**ADDENDUM TO RFP DOCUMENTS**

<b>SOLANO</b> COMMUNITY COLLEGE 	ADDENDUM #01
	Project: #16-015 Solano Community College District Site Lighting Improvements Project
	Date: March 29, 2016

**ITEM NO. 1 – PLAN SHEET 0.00 – COVER SHEET, INDEX**

3 ADD ALTERNATE AREA #1  
SCALE: 1/4"=1'-0"

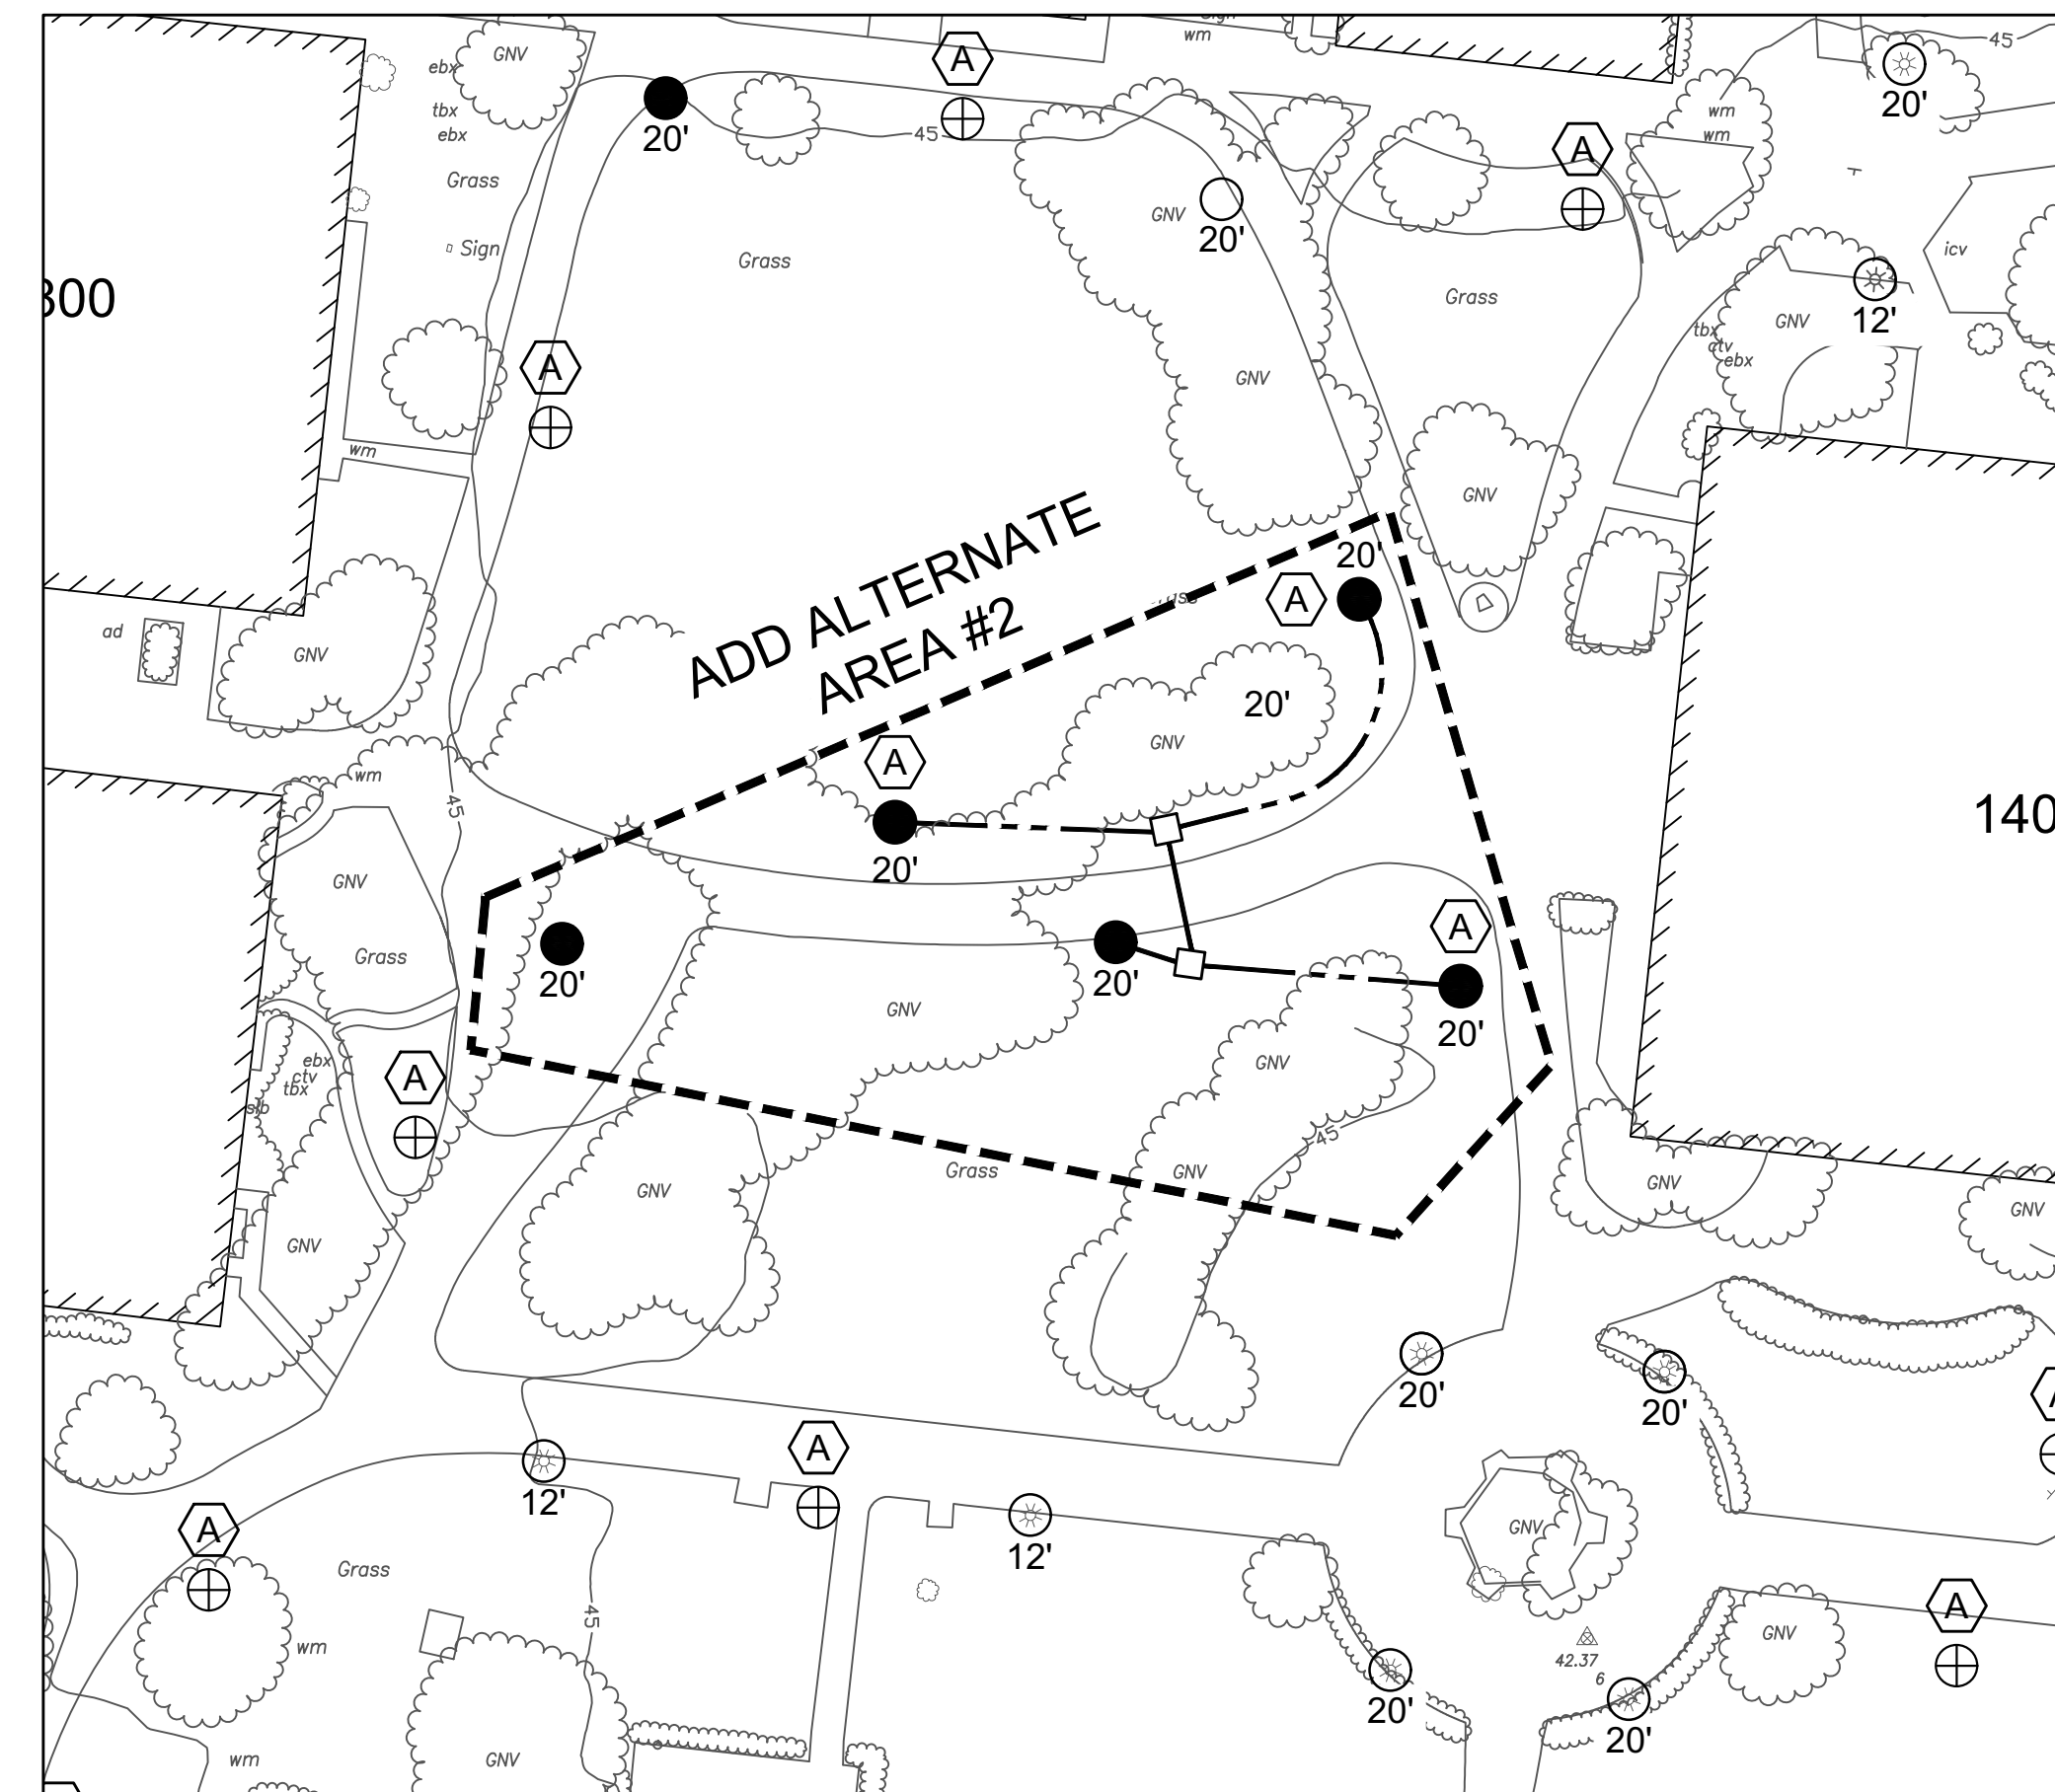
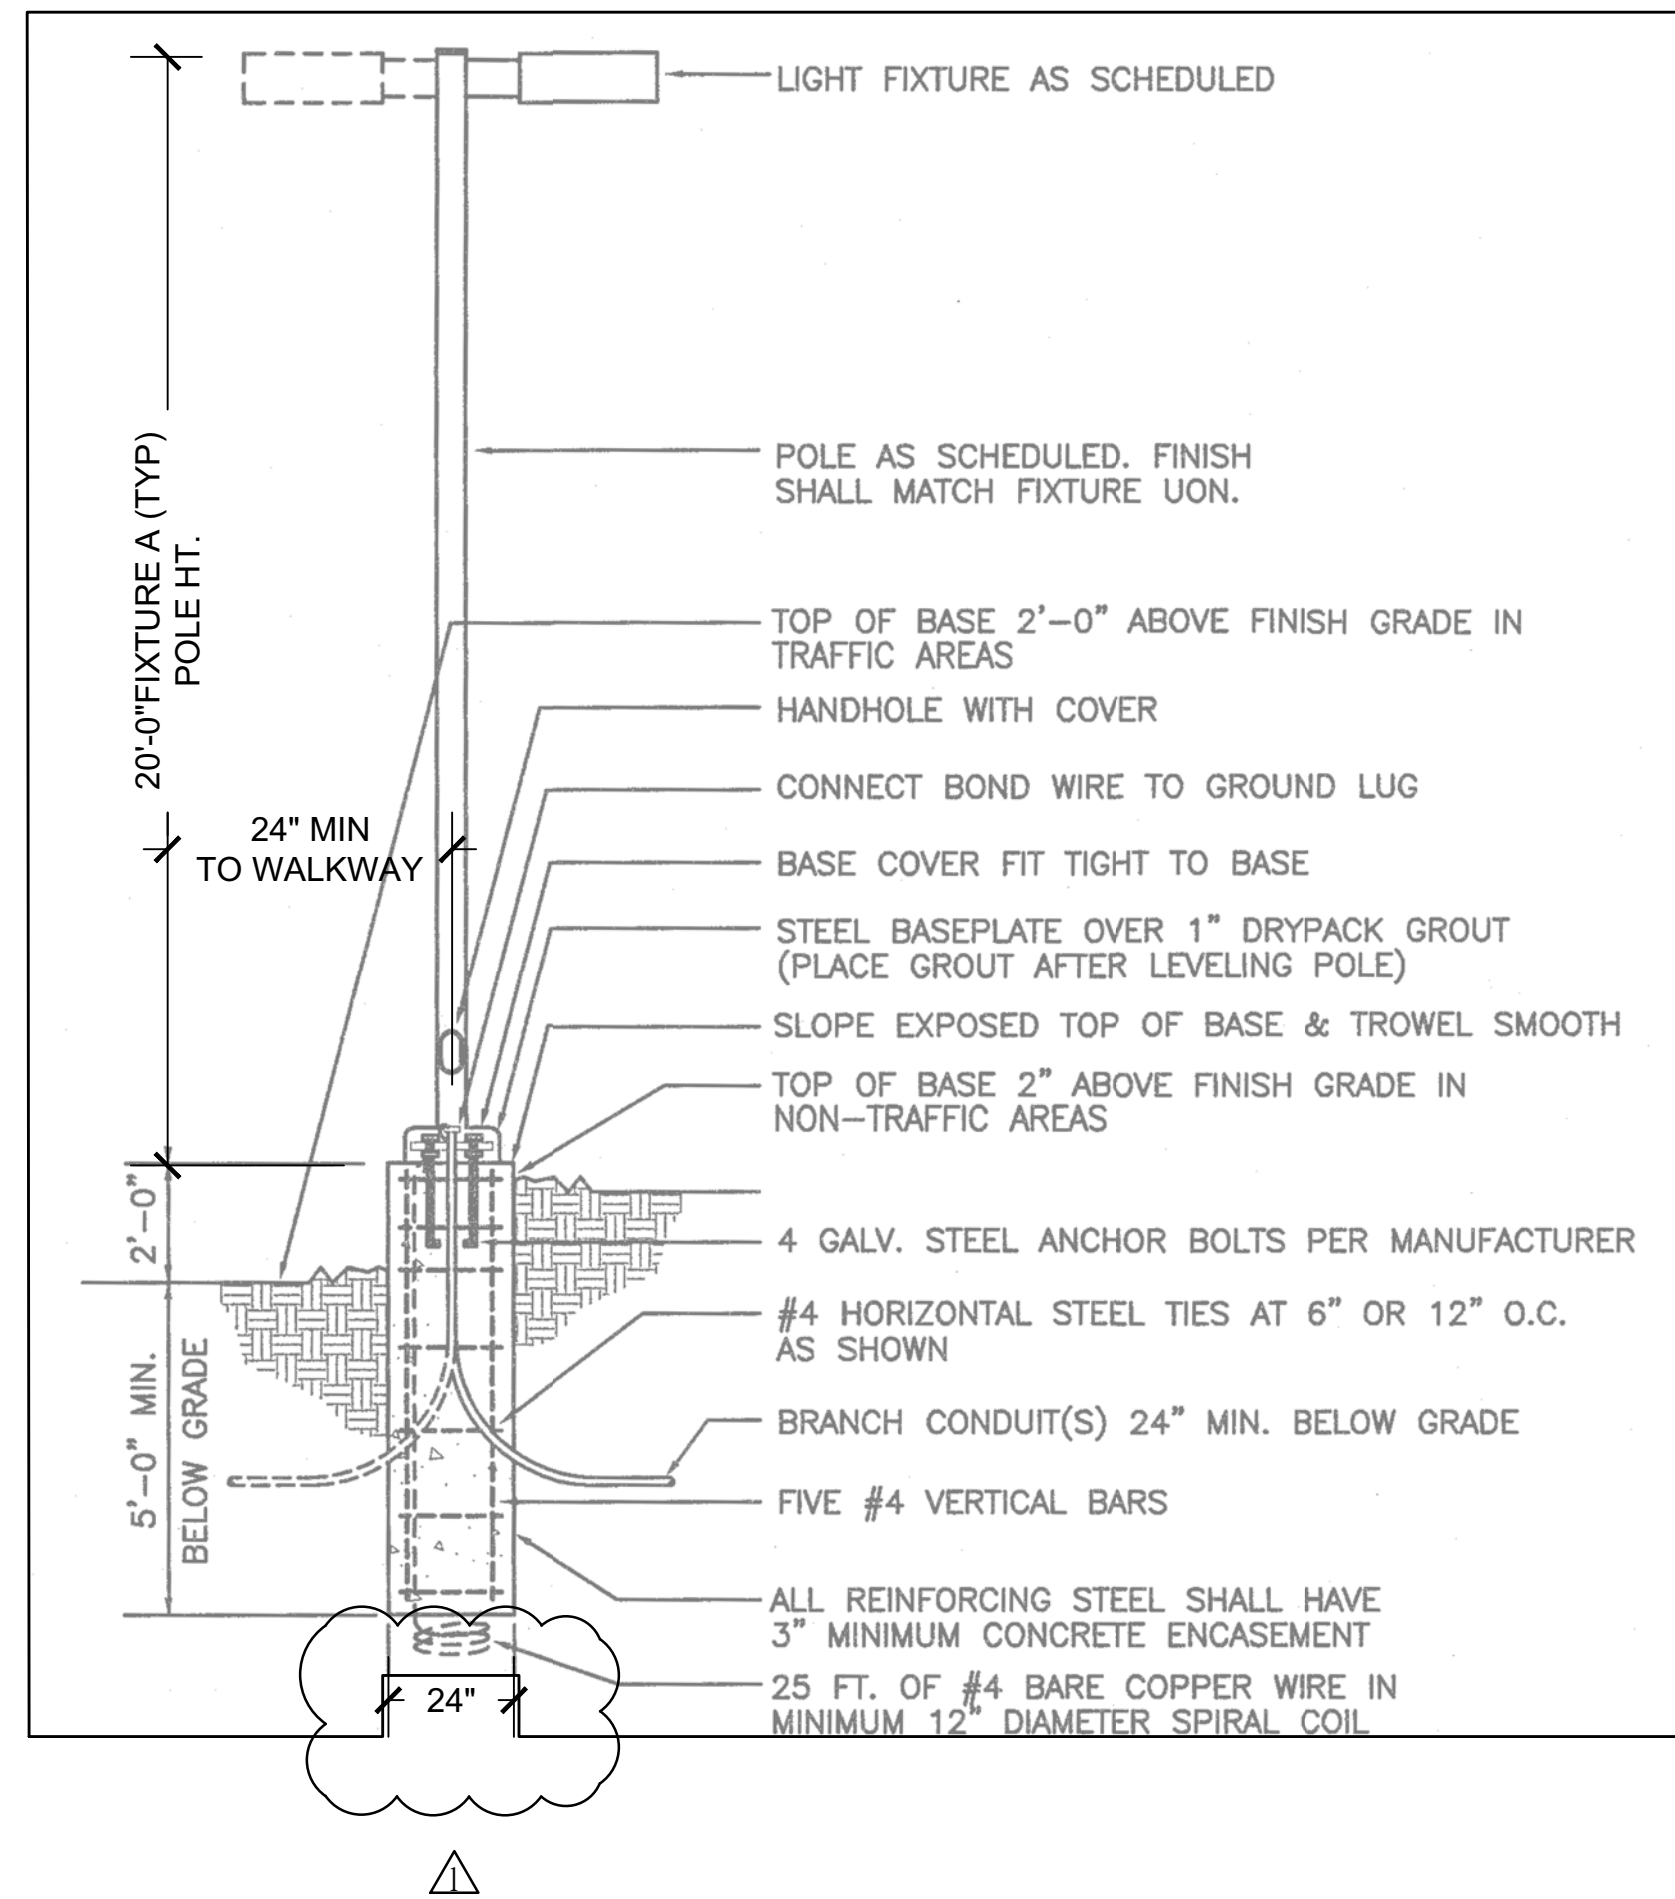
**ITEM NO. 3 – PLAN SHEET EL 101 – ENLARGED PLAN BASE BID AREAS #1 & #2 & ADD ALTERNATE AREAS #1 & #2**

Replace ‘Plan Sheet EL 101’ with attached revised ‘Issue for Addendum #1 3/30/16 – Plan Sheet EL 101’. Revisions include the following:

- Delete Fixture Types ‘B’ and ‘C’ from ‘Light Fixture Schedule’.

EL102

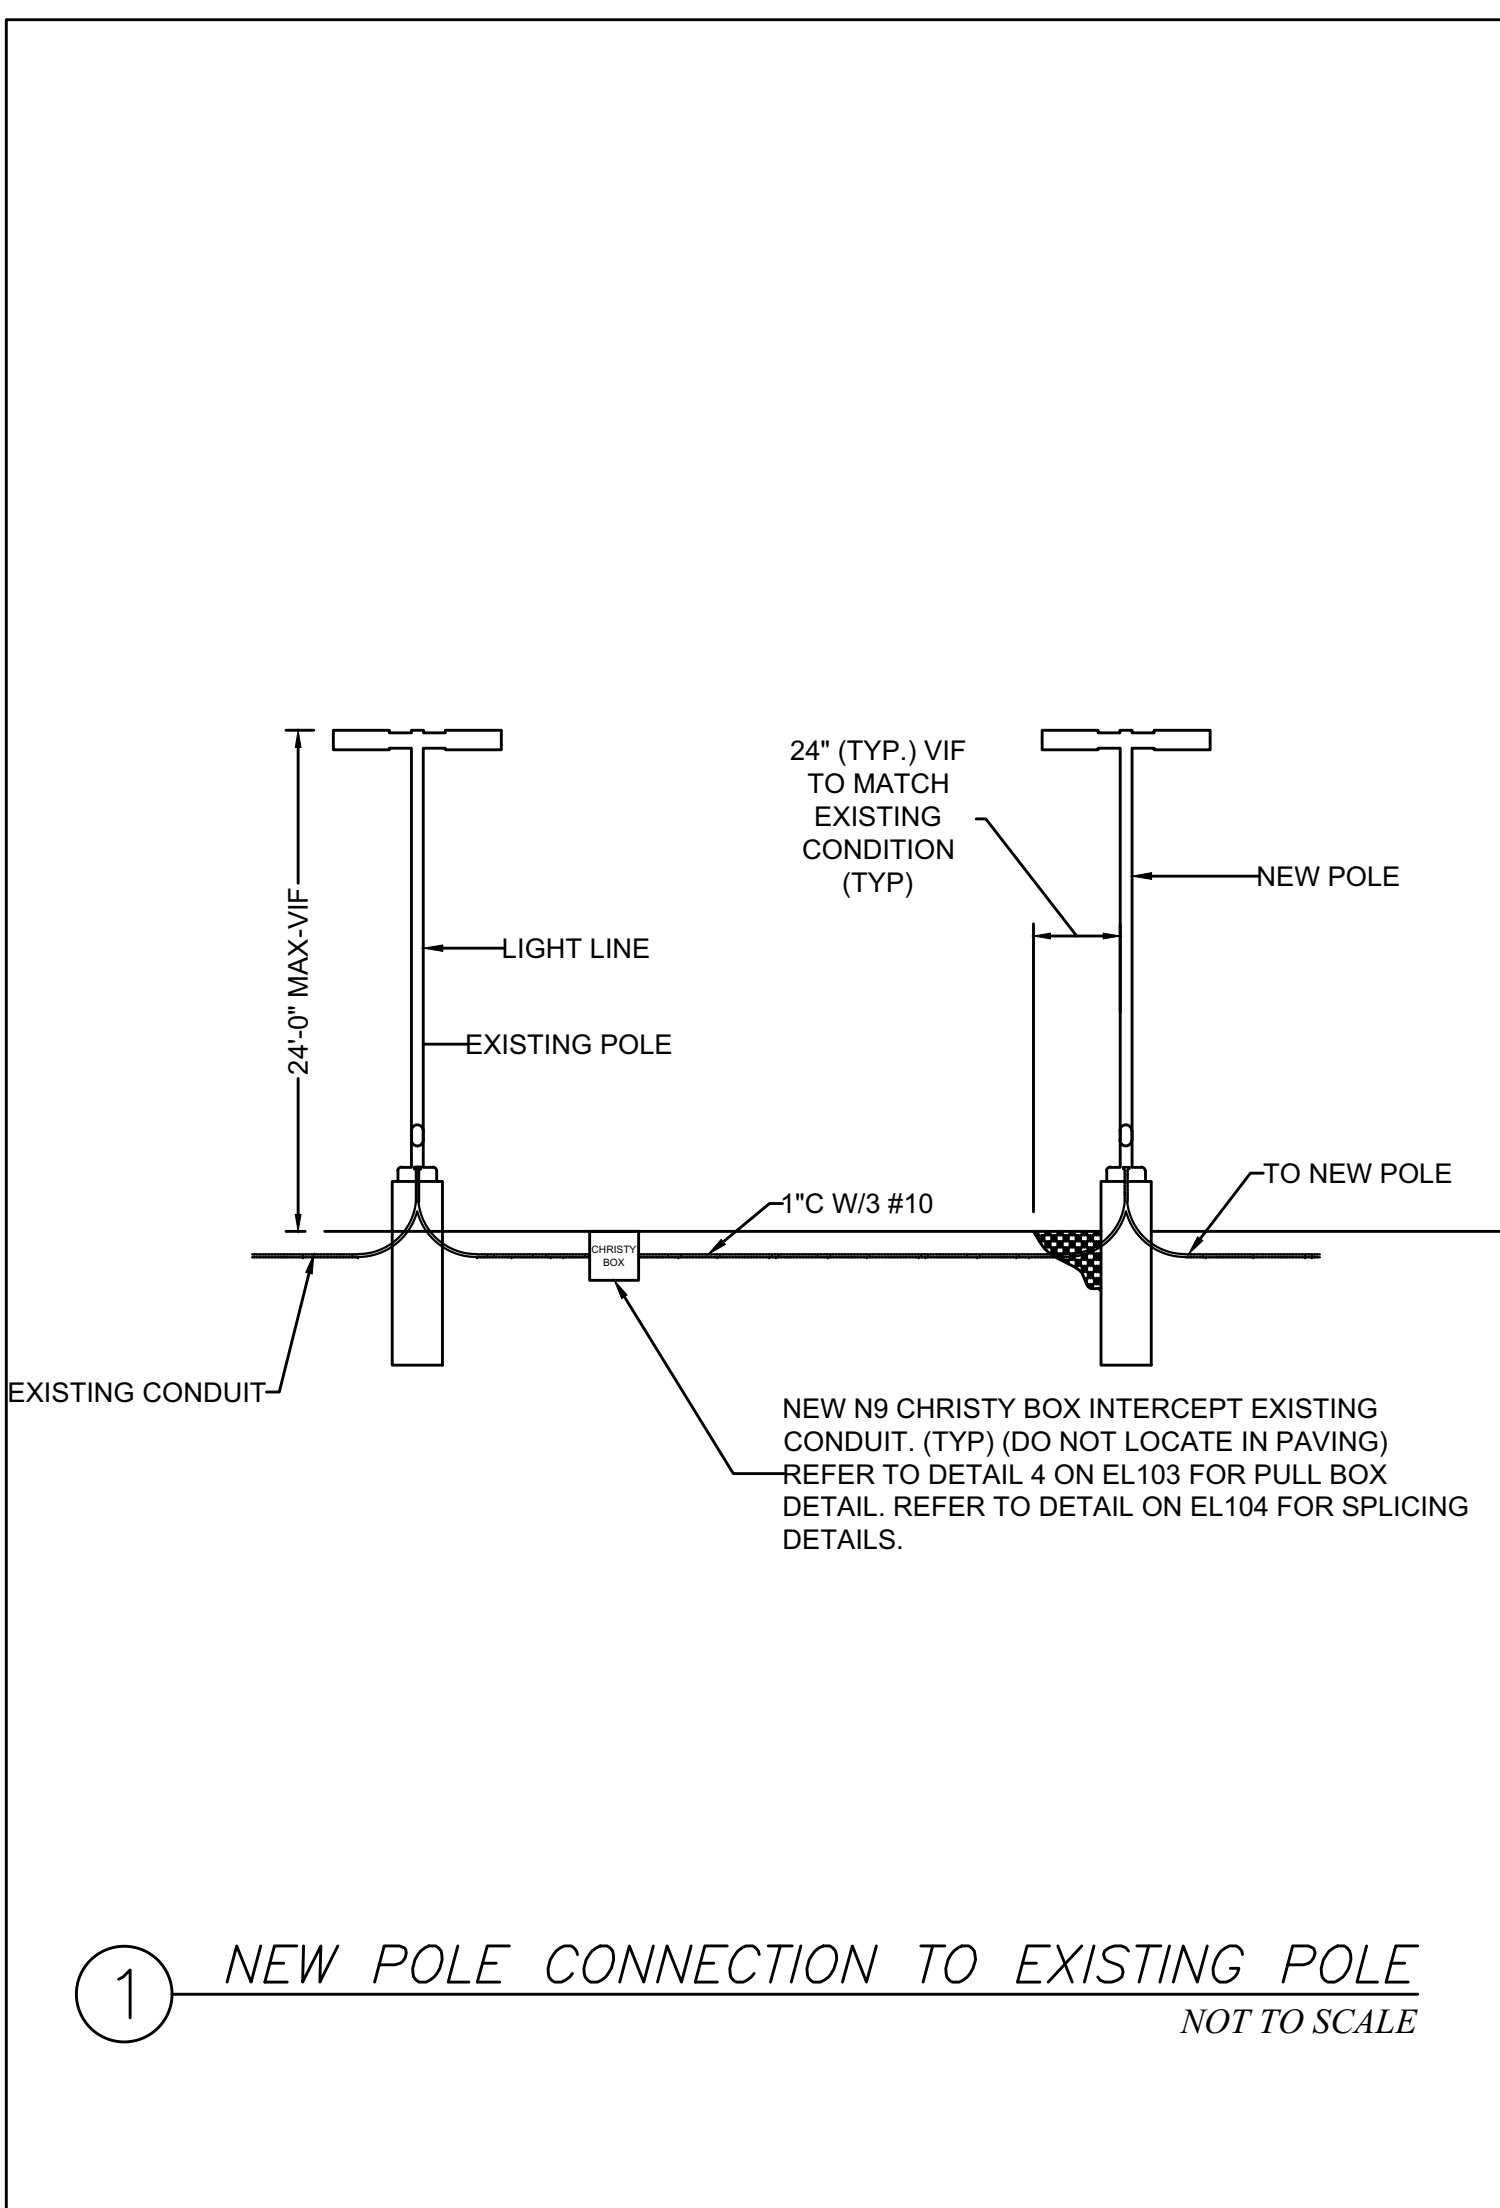
**ITEM NO. 4 – PLAN SHEET EL 102 – CUT SHEETS & DETAILS**

Replace 'Plan Sheet EL 102' with attached revised 'Issue for Addendum #1 3/30/16 – Plan Sheet EL 102'. Revisions include the following:

- Added note for detail 1/EL 102 – 'Pole Mounted Fixture on Concrete Base' to see 5/EL 103 for additional requirements for light pole and base.
- Delete detail 3/EL 102 – 'Fixture Type 'A' Existing Interior Pole' and replace with 'New RAB Fixture Pole'.
- Added note for new detail 3/EL 102 – 'New RAB Fixture Pole' to clarify model numbers for specified poles.

NOTES:  
SEE EL103, DETAIL #5 FOR ADDITIONAL REQUIREMENTS (TYP.)

NOTES:  
RSS-S-20-A-TC-1-S2-DB-UL: TO BE USED WITH NEW RAB FIXTURE POLE RSS-S SERIES  
RSS-S-20-60C-1-S2-DB-UL: TO BE USED WITH NEW PV LIGHT CIMARRON DC CRID  
\* CONFIRM PART NUMBERS WITH MANUFACTURE
